City of Poulsbo

Subject: Pinnacle at Liberty Bay PRD and Preliminary Subdivision | P-06-20-25-03 | Request for Revisions

To: Montebanc Management LLC
From: Nikole Coleman, AICP, Planning Manager
Subject: Pinnacle at Liberty Bay PRD & Preliminary Subdivision; Request for Revisions; P-06-20-25-03
Date: September 8, 2025

Re: Pinnacle at Liberty Bay: Third-Party Review

SITE MAP

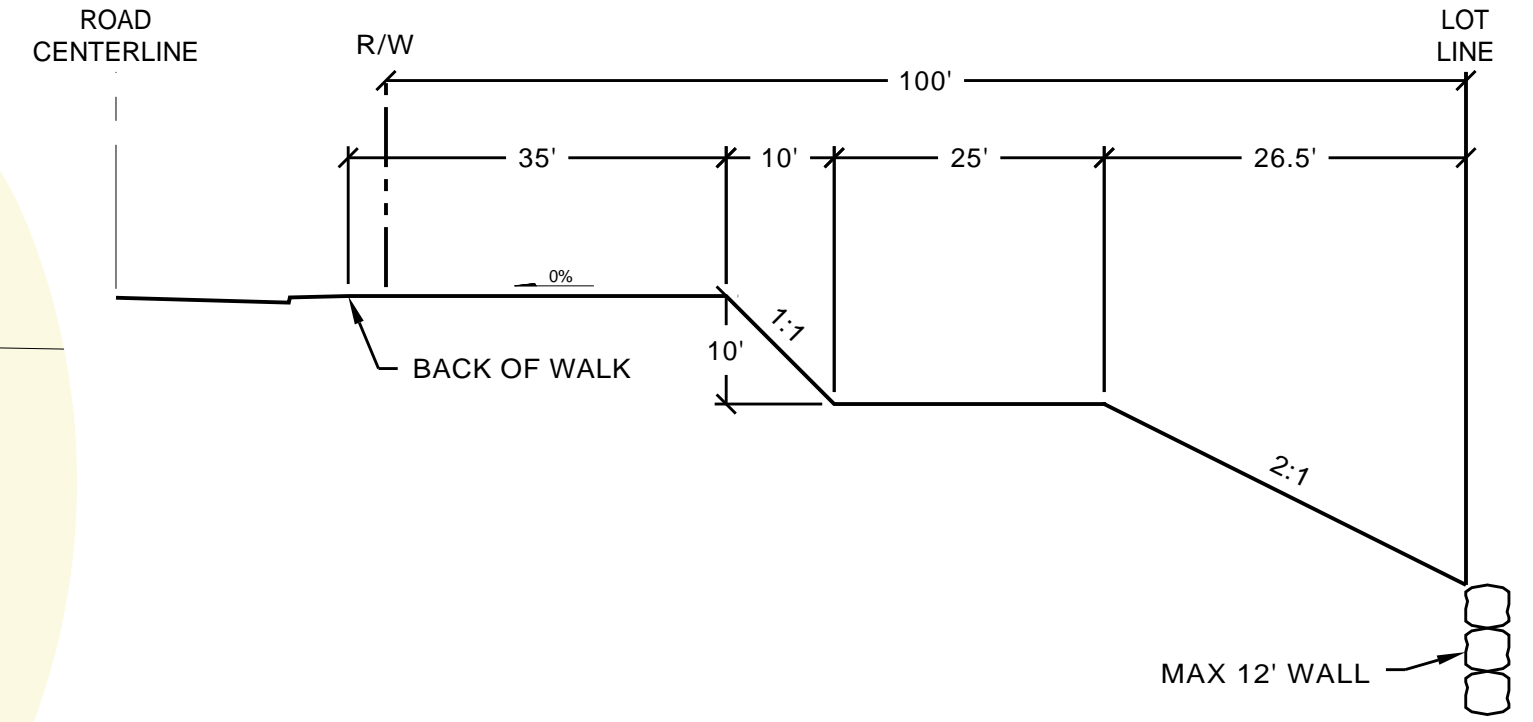
In addition to the identified wetlands, Grette identified four streams (Streams A, B, C, and D) within the project site (Attachment 1). Grette largely concurs with the mapped locations of these features. However, based on the site assessment Stream B appears to flow into Wetland B, which is not clearly shown on the delineation map or site plans.
